**ECONOMIC COMMISSION FOR EUROPE**

Working Party on the Transport of Dangerous Goods

## PROPOSALS FOR AMENDMENTS TO ANNEXES A AND B OF ADR

Section 9.2.2.5, 9.7.8 and 8.3.8: Explosion protectionTransmitted by the Government of Germany

**Example for consequences: Road tanker for class 3 with vapour recovery**

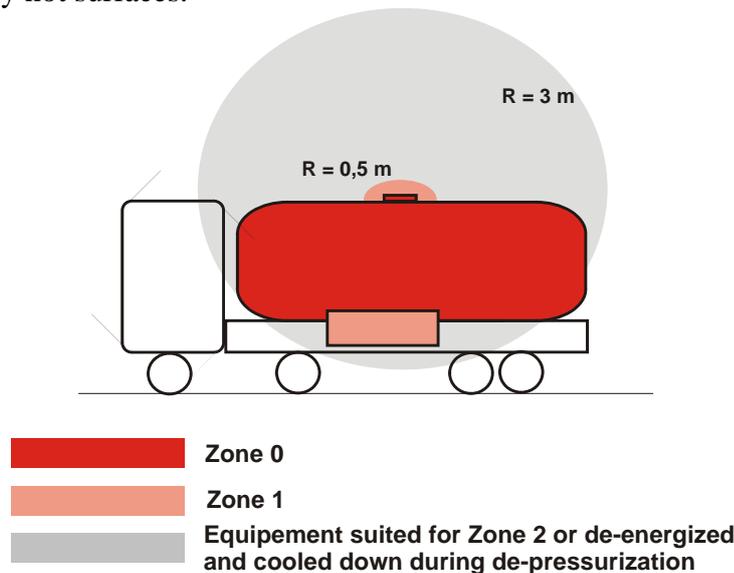
It is supposed that no automatically acting venting device is provided. De-pressurization of the tank is carried out by opening the dome hole cover – this has to be done before filling in order to introduce the loading arm with integrated vapour recovery line. The vapour recovery is performed by fitting the arm gas tight to the dome hole. This type of vehicle is typically used for chemicals in Germany. The following figure indicates the attributed zones respective areas where operational requirements shall be imposed according to the results of the research project:

Zone 0: Inside tank compartments, fittings for filling and discharge and vapour recovery lines (same as ADR).

Zone 1: Inside cabinets for equipment used for filling and discharge and within 0,5 m from the dome hole cover.

In a sphere with radius of 3 m around the dome hole electrical as well as non-electrical equipment which is not in a Zone

Zone 1 shall additionally be attributed to those junctions and fittings of the vapour space and vapour recovery line which are not permanently gas tight in a technical sense. According to the findings in the project this applies to dome holes which are operationally closed and opened and which are likely to show slight leak rates. As a consequence a small (radius 0,5 m) Zone 1 should be attributed.

A remaining controlled area covering permanently energized equipment is cut down from the whole tank vehicle as required by the present ADR to a sphere with radius 3 m around the source. Furthermore, the requirement for permanently energized equipment is reduced from “suitable for Zone 1” to “suitable for Zone 2”. Alternatively in this controlled area de-energizing or cooling down of hot surfaces is acceptable. The latter requirement will rarely be onerous because in the project it is found that temperatures below about 300 °C are sufficient to avoid ignition.

- shall comply with the requirements for use in Zone 2 or
- shall during de-pressurization of the tank be de-energized or switched-off or cooled down to avoid ignition by hot surfaces.
